**ATLANTIC COAST PIPELINE, LLC  
ATLANTIC COAST PIPELINE**

**DOMINION TRANSMISSION, INC.  
SUPPLY HEADER PROJECT**

**Revised Site Specific Geohazard Mitigation Design Drawings**

Date: 22 December, 2016  
To: Colin Olness, Dominion  
Copies to: Tony Rice, Geosyntec Seattle  
From: Logan Brant, Geosyntec Houston  
Subject: Revision C Updates to Site Specific Geohazard Mitigation Design Drawings  
MNF and GWNF Sites - Atlantic Coast Pipeline  
Geosyntec Project: TXG0007 / 013 / 1210

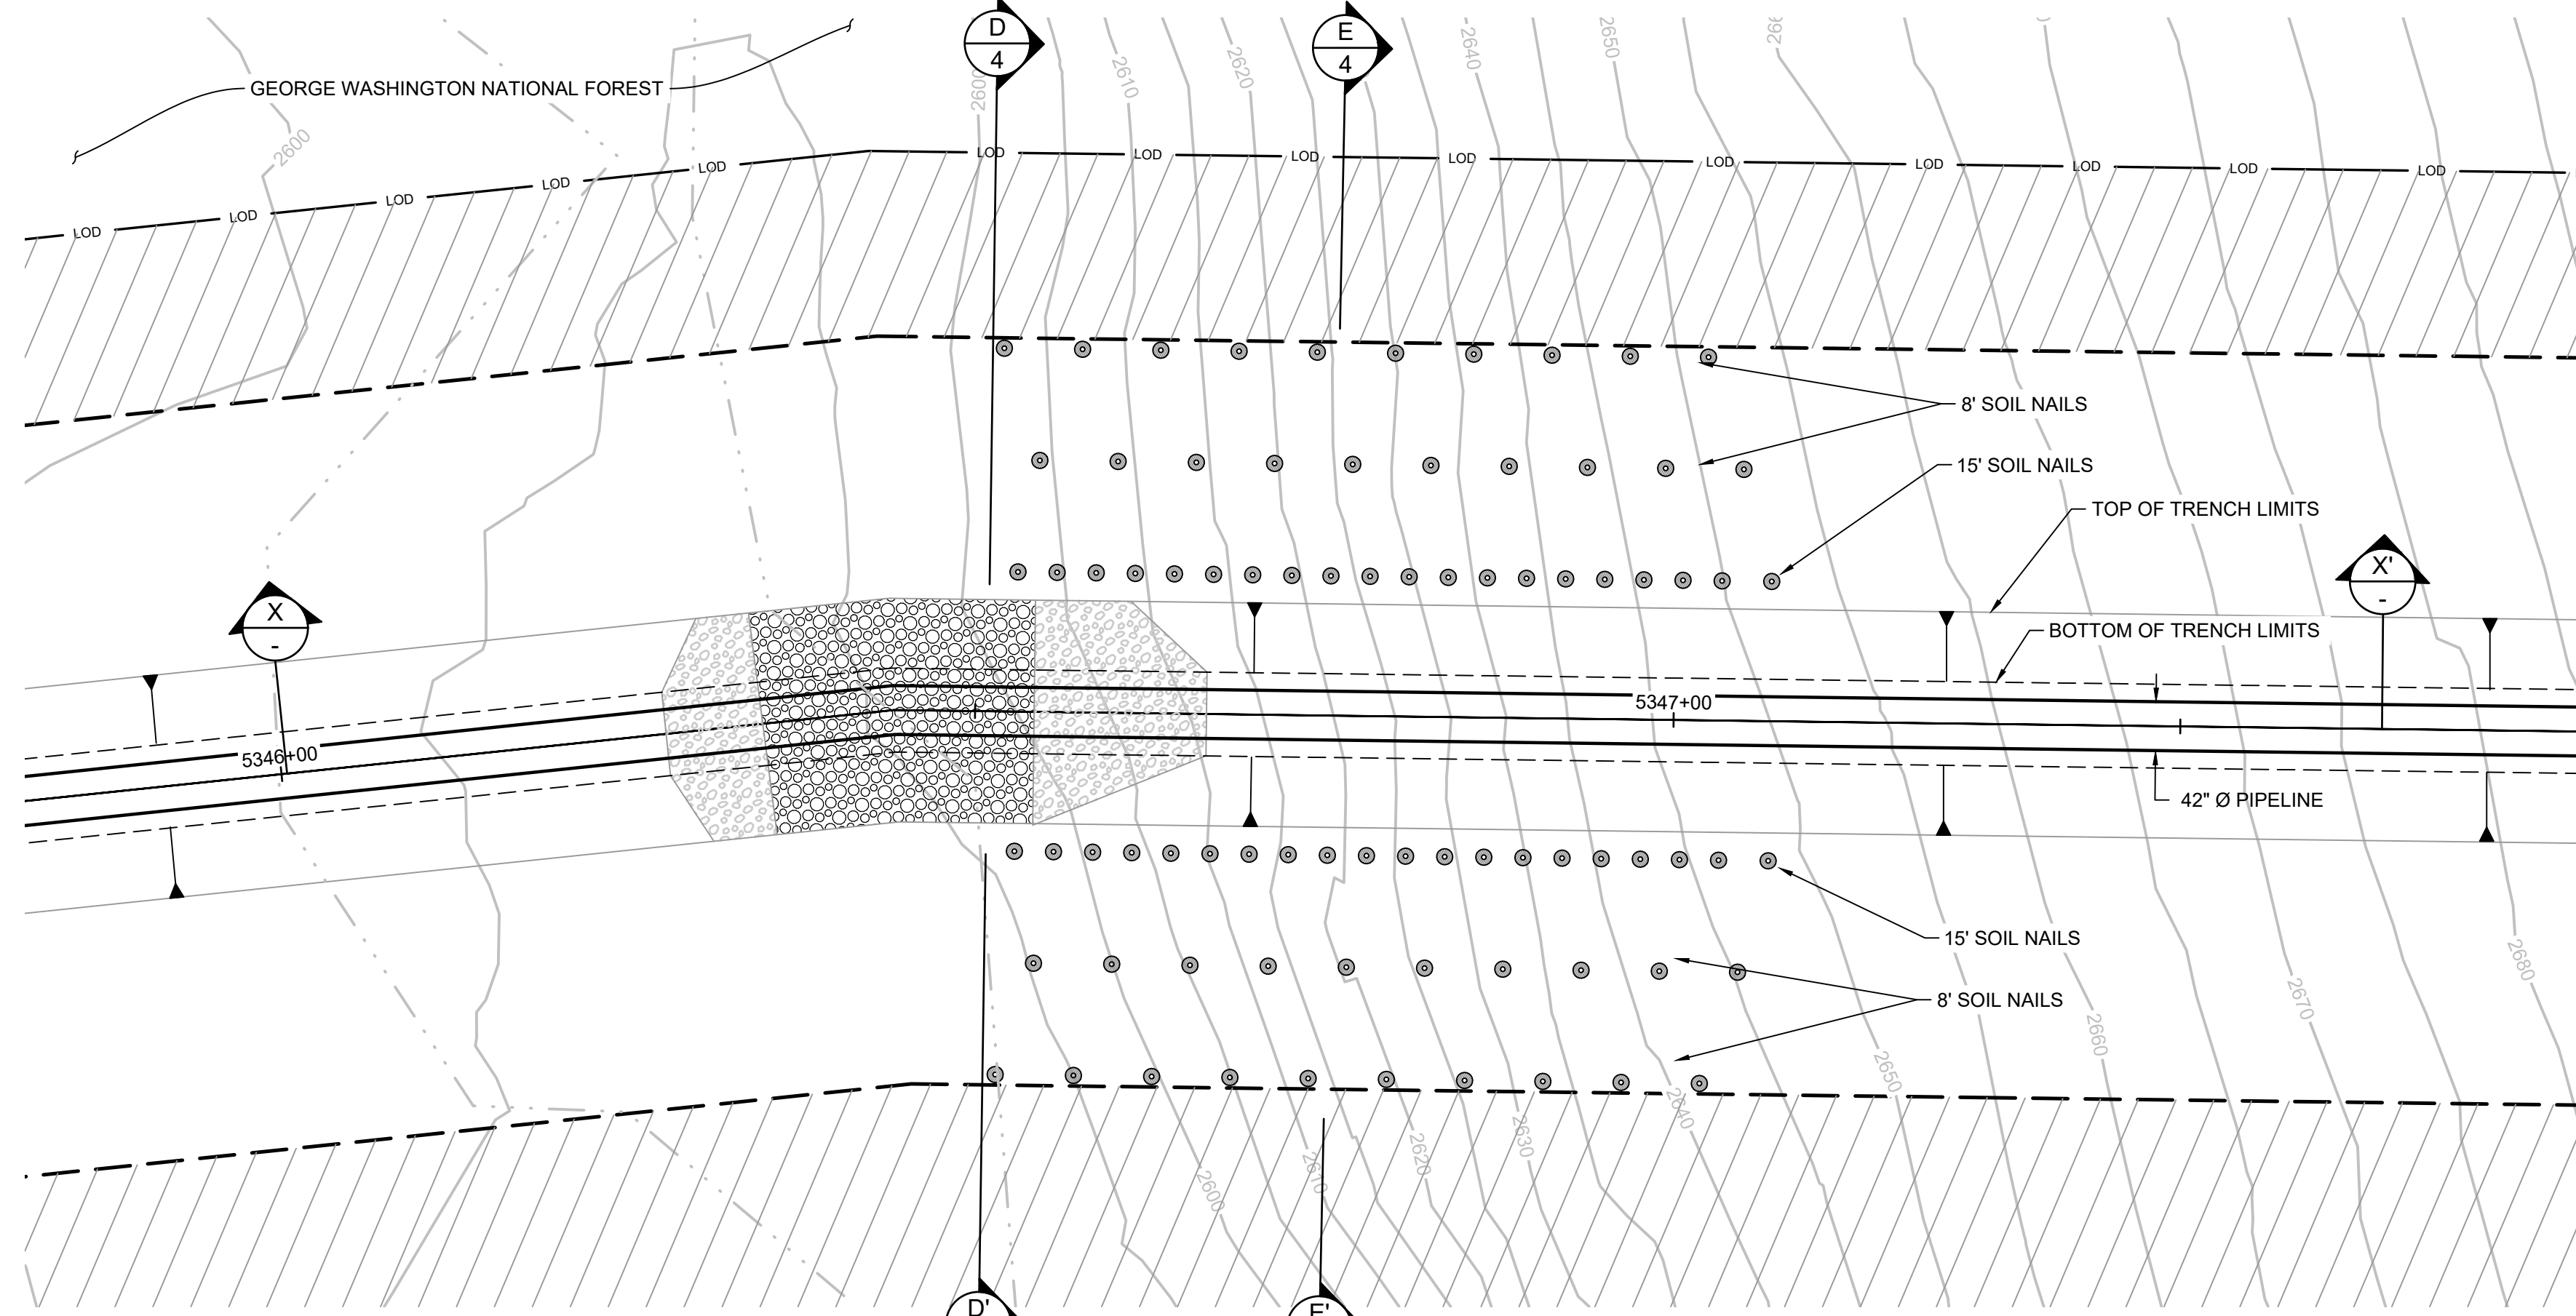
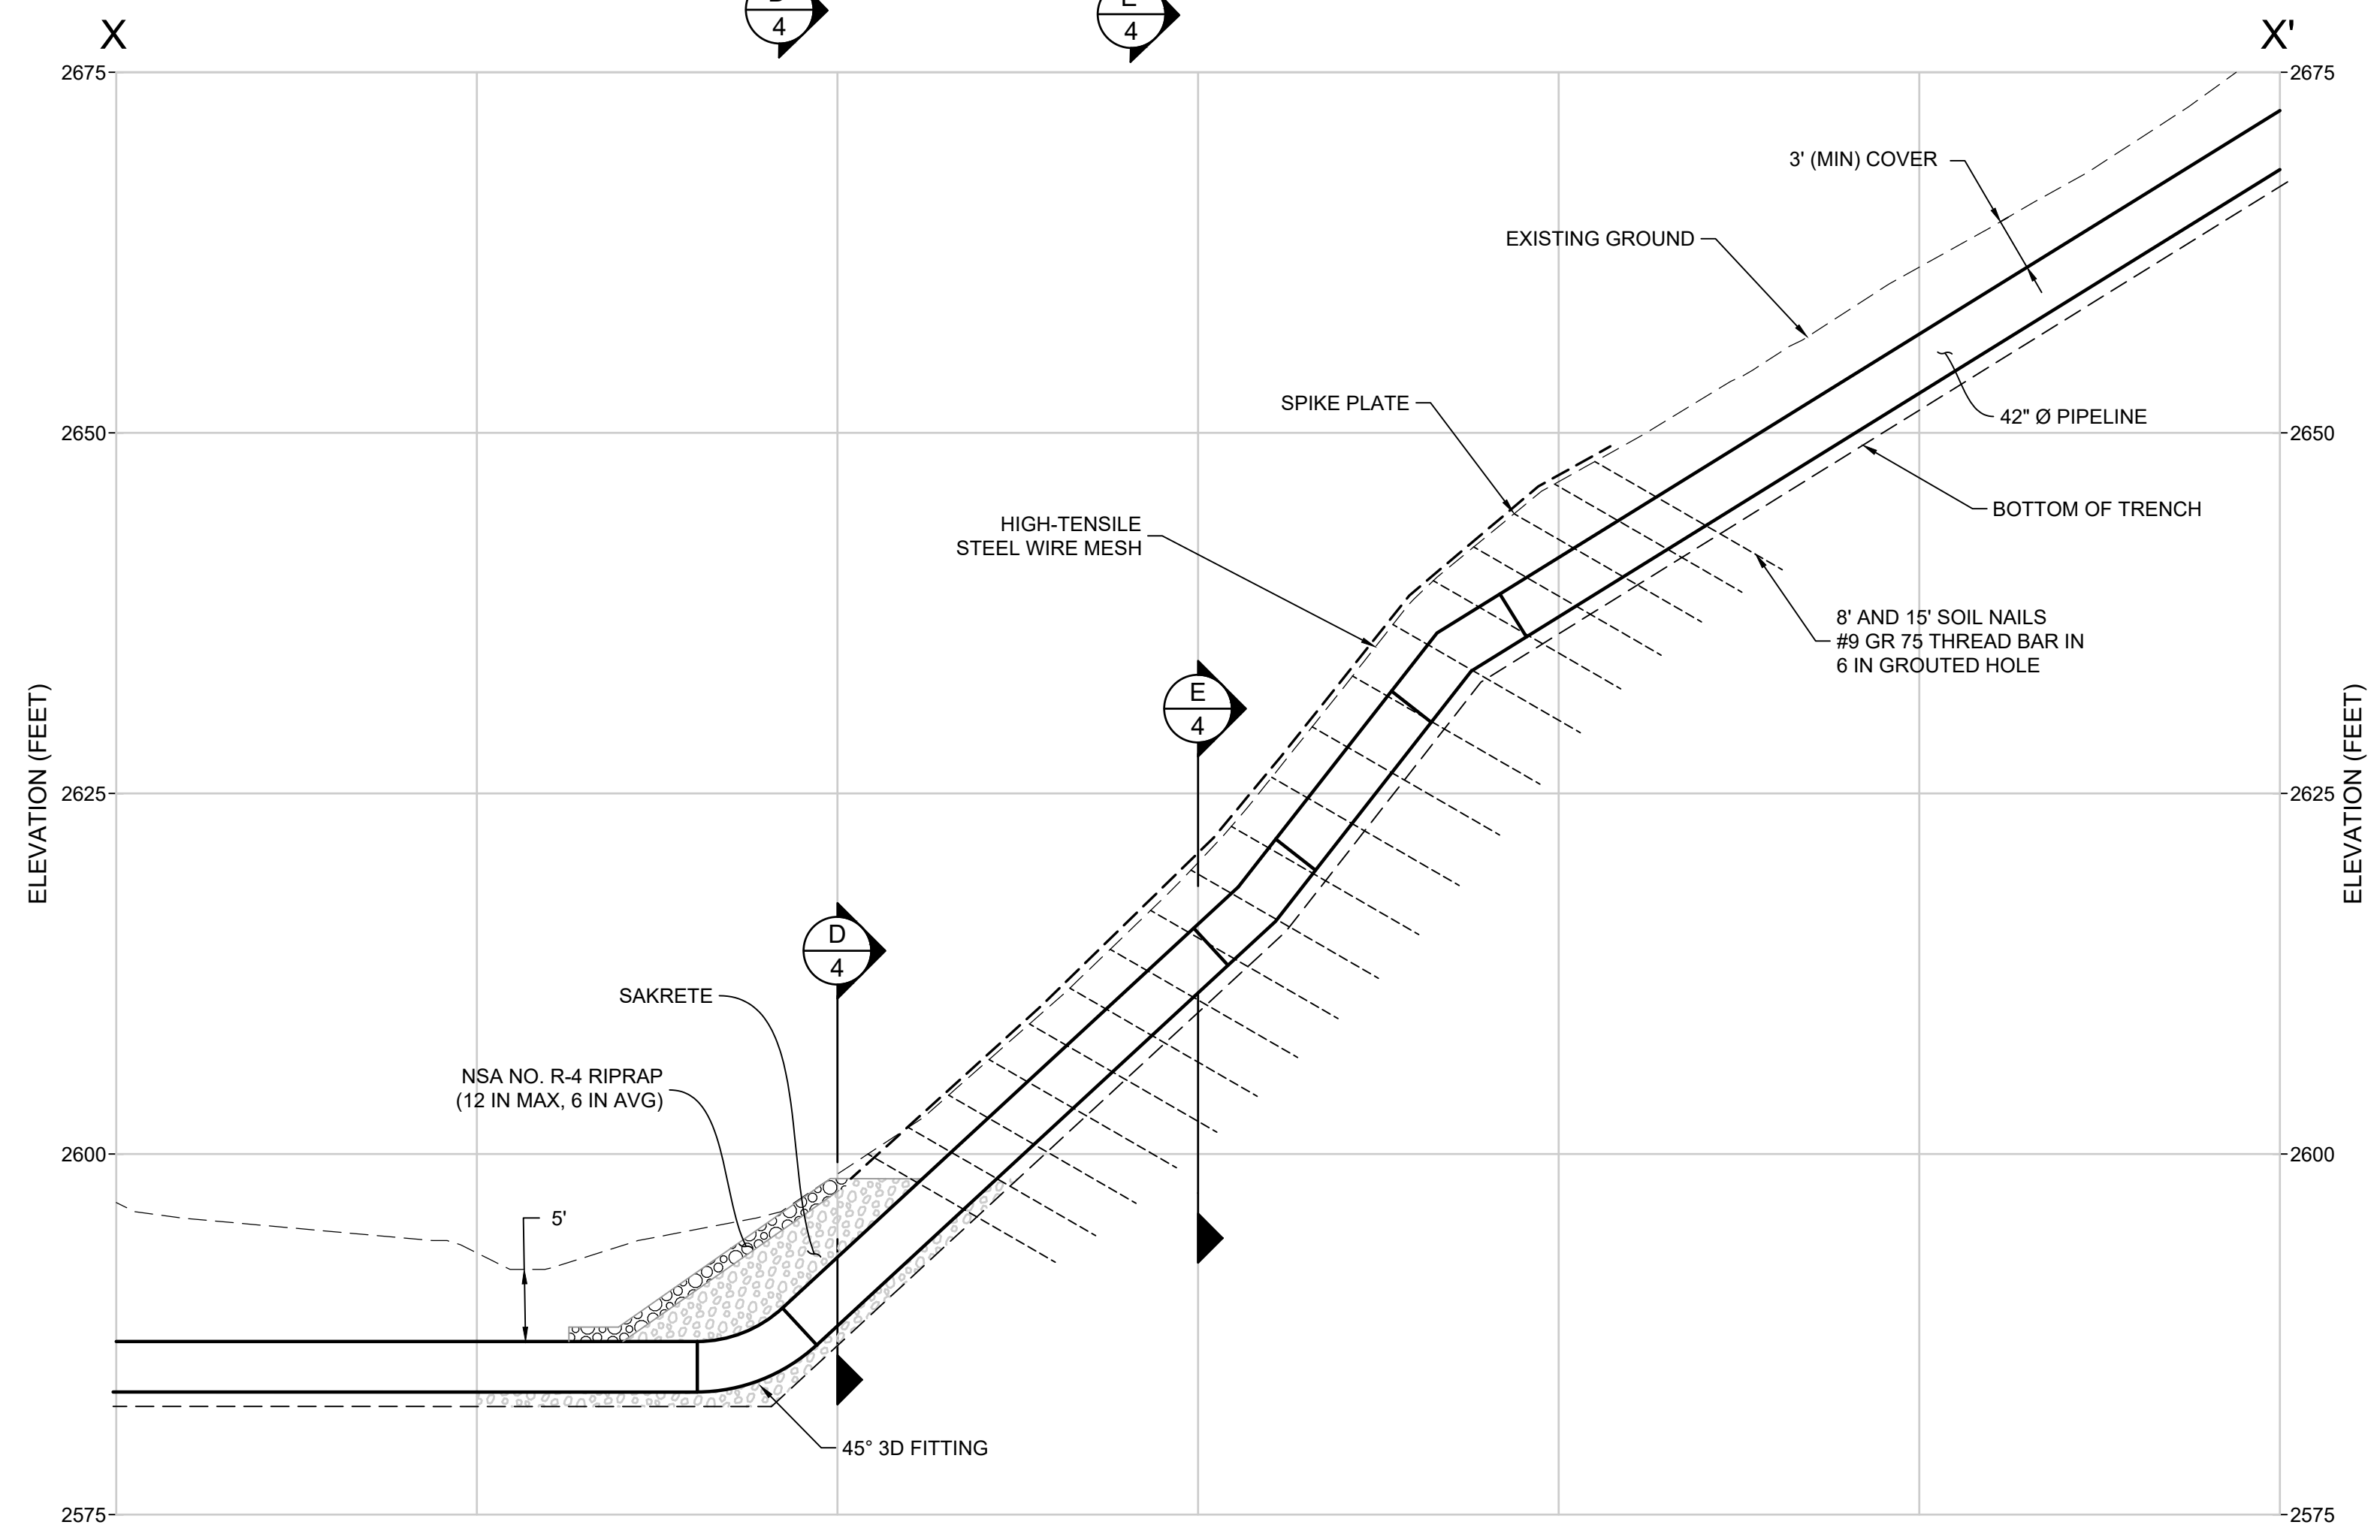
ACP AP-1 MP 84.95 to 85.05 – Detailed Plan and Profile X-X':

- Revision C line added to the revision block.
- Drawing set expanded from 4 to 5 drawings, so drawing numbering now shows “of 5”.
